# OU-1 TECHNICAL UPDATE: REMEDY CHANGES BASED ON INVESTIGATION AND DESIGN

West Lake Landfill Superfund Site  
Bridgeton, MO

August 29, 2024

OU-1 and OU-2 Remedy Changes

# Site Overview

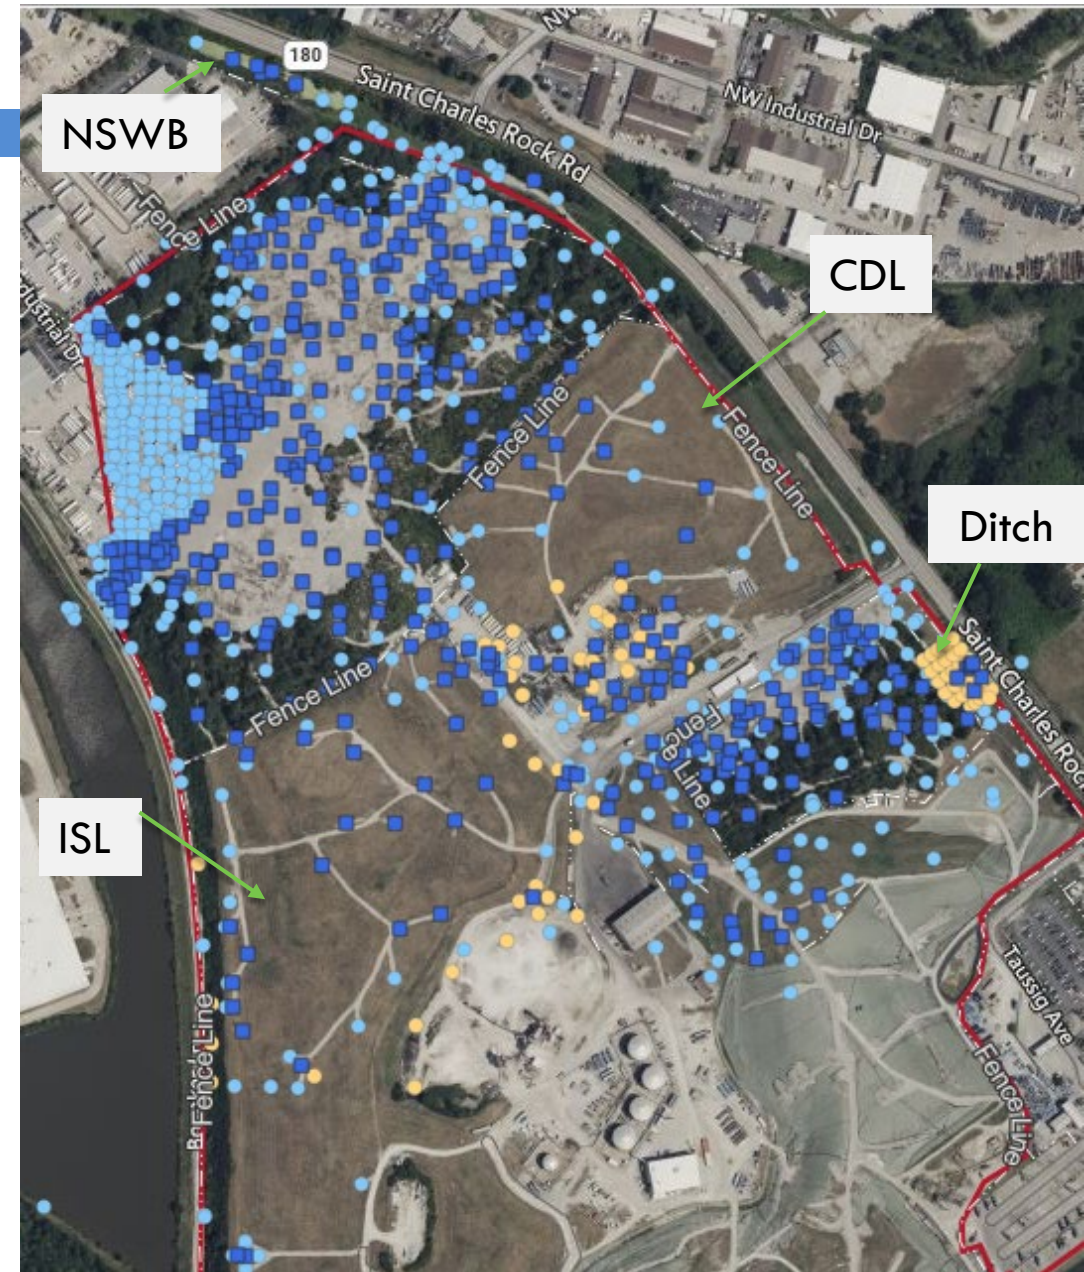
- Design Investigation (DI) Found RIM in Additional Areas:
  - Construction and Demolition Landfill (CDL)
  - Northern half of the Inactive Sanitary Landfill (ISL)
  - North Surface Water Body (NSWB) & ditch along St. Charles Rock Road
- DI also determined there is less high concentration RIM.
- Based on results of DI, there will be some modifications to the remedy selected in the 2018 RODA.

# Adjustments to the OU-1 Remedy

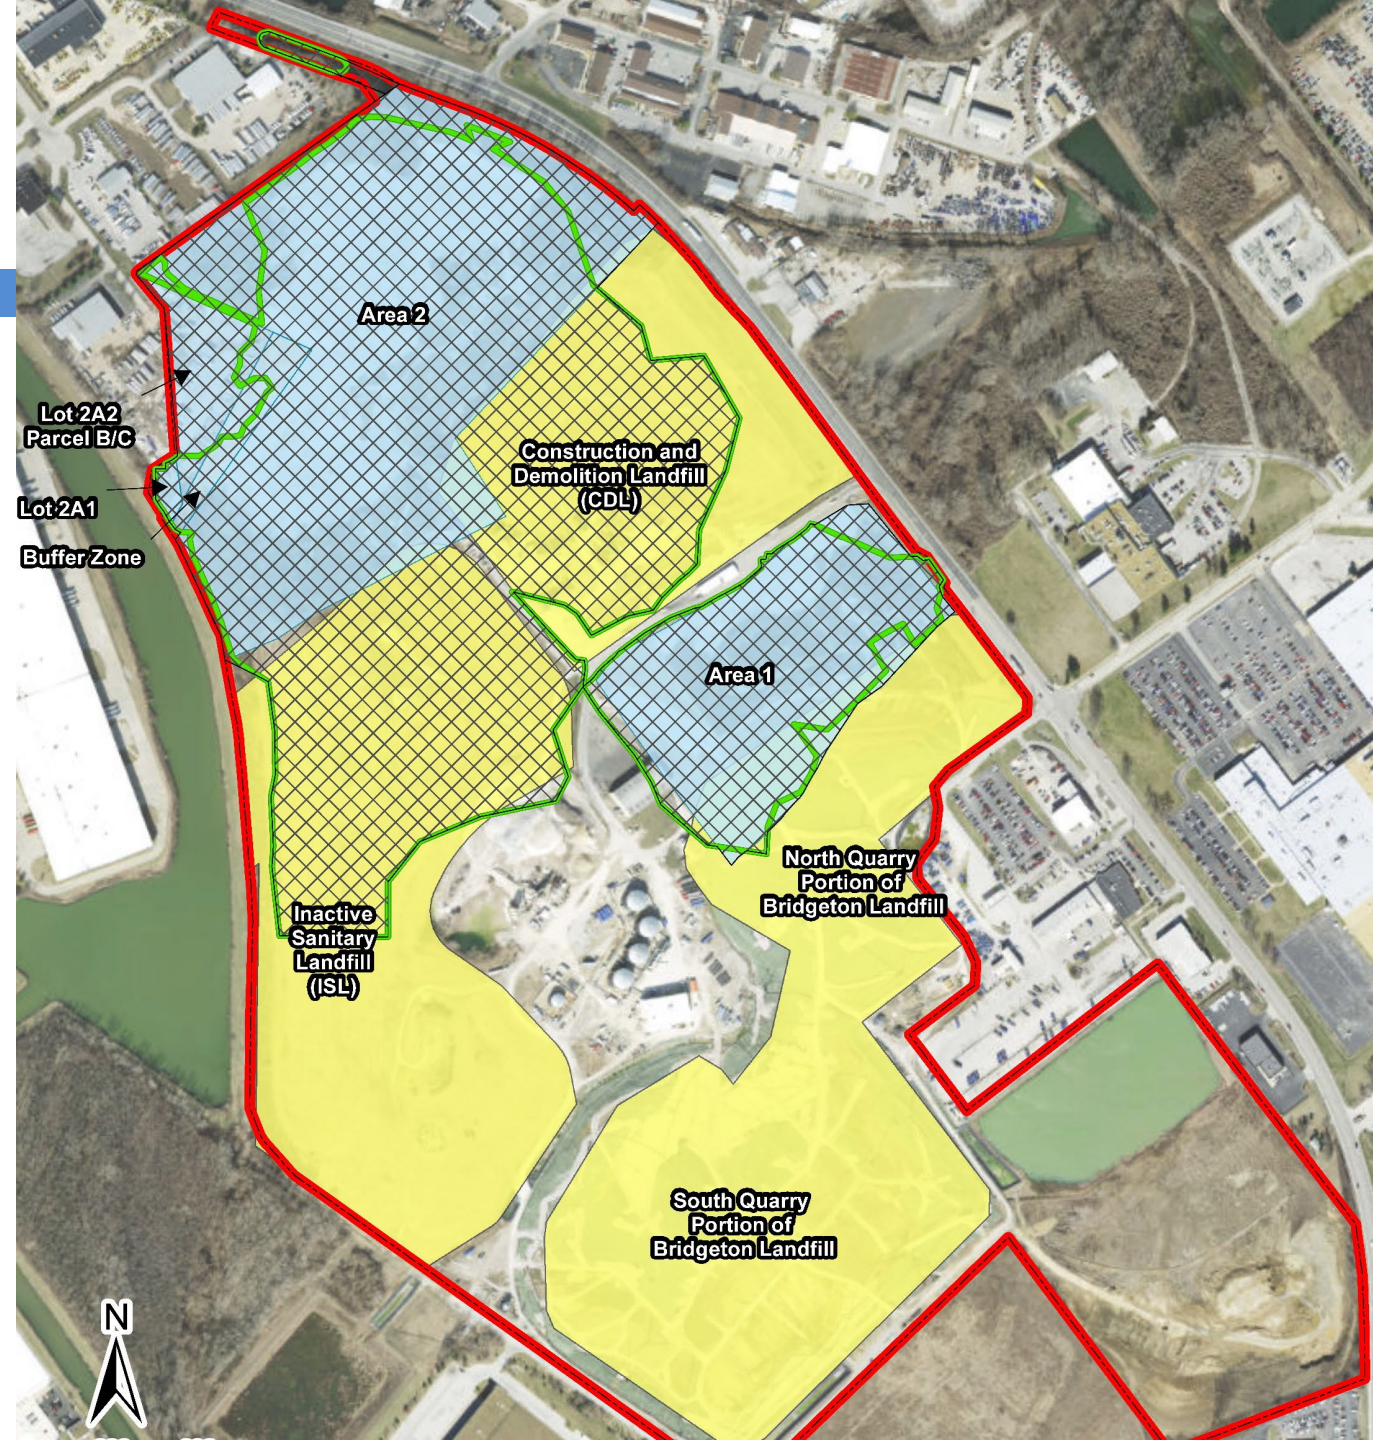
- Changes to OU-1 remedy selected in 2018 RODA
  - ▣ Expand OU-1
  - ▣ Increase in estimated cost.
  - ▣ Change in required slope for the top of the engineered cover
  - ▣ Direct RIM/waste loading – changing the need for RIM staging and loading building to conditional rather than required
  - ▣ Pre-excavation confirmation sampling rather than during and after the excavation of RIM
  - ▣ Elimination of the on-site laboratory requirement

# 5<sup>th</sup> Change - Confirmation Sampling

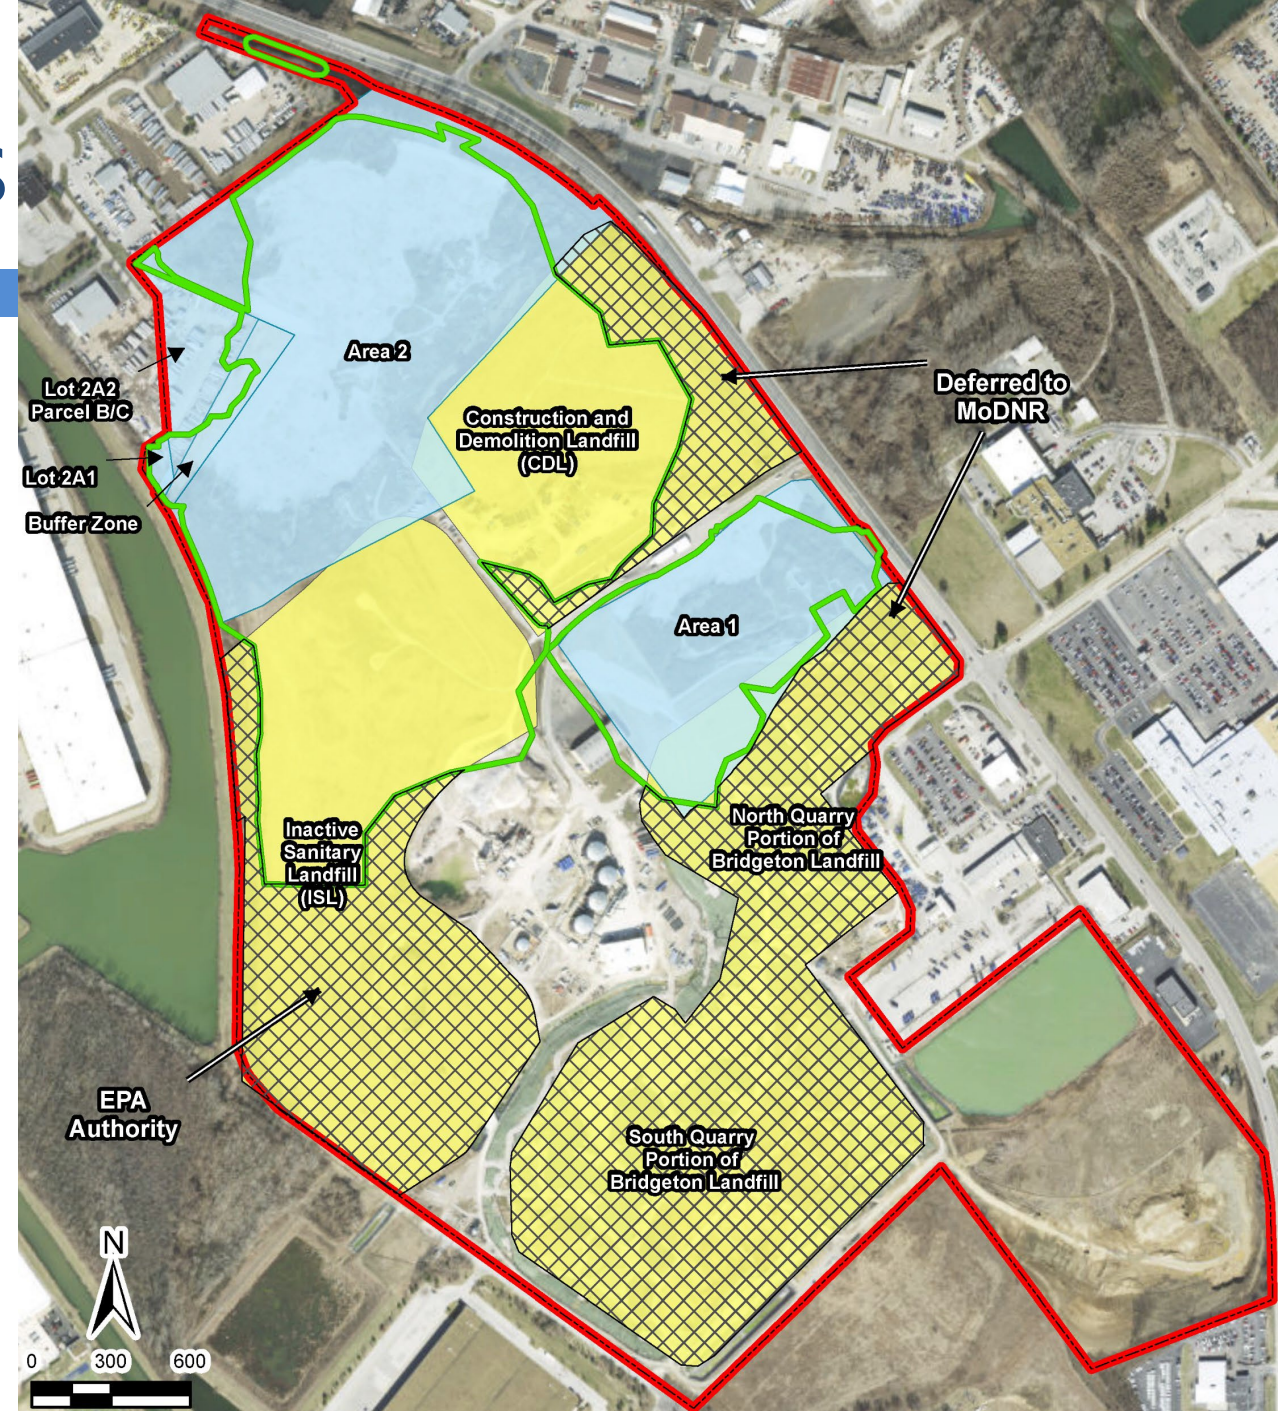
- PRPs have proposed pre-excavation confirmation sampling
  - ▣ Confirmation samples are collected outside the proposed excavation boundary by drilling borings to collect samples before excavation begins.
  - ▣ The excavation boundary will be divided into decision units.
  - ▣ If the average concentration of samples in a decision unit exceeds the excavation criteria (52.9 pCi/g), the excavation boundary will be expanded, and additional samples will be collected.
  - ▣ This process would continue until the proposed excavation is confirmed as accurate.
  - ▣ Excavation would proceed along the confirmed boundary and backfilling would occur as the excavation moves forward.
  - ▣ This means additional sampling would occur before excavation begins.
